Submission in relation to: Application Number - SSI 7485
Application name - WestConnex M4-M5 Link

I object to the WestConnex M4-M5 Link proposals as contained in the EIS application #SSI 7485 for the reason(s) set out below.

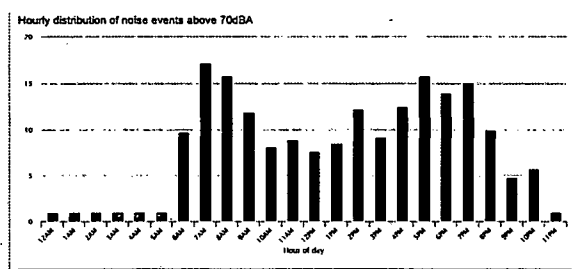
- I object** to the EIS because the proponent has failed to take account of the cumulative impact of its proposed Darley Road, Leichhardt civil and tunnel site operations and the aircraft noise which the residents near the site already endure.

The attached extract from Webtrak shows that Darley Road, Leichhardt and adjacent streets are directly under the flight path.

Airservices Australia reports that in April to June 2017 the number of average daily noise events over 70 dBA. In Leichhardt this is an average of 16- 17 per hour over the peak morning period and 16 per hour in the early evening peak period.

I object to the plan for a construction site on Darley Rd because this will mean an additional cumulative impact of spoil truck diesel engine, exhaust and potentially air brake noise every 4 minutes in peak hour based on number of truck movements per hour and in excess of every 4 minutes per hour in non peak permitted construction hours.
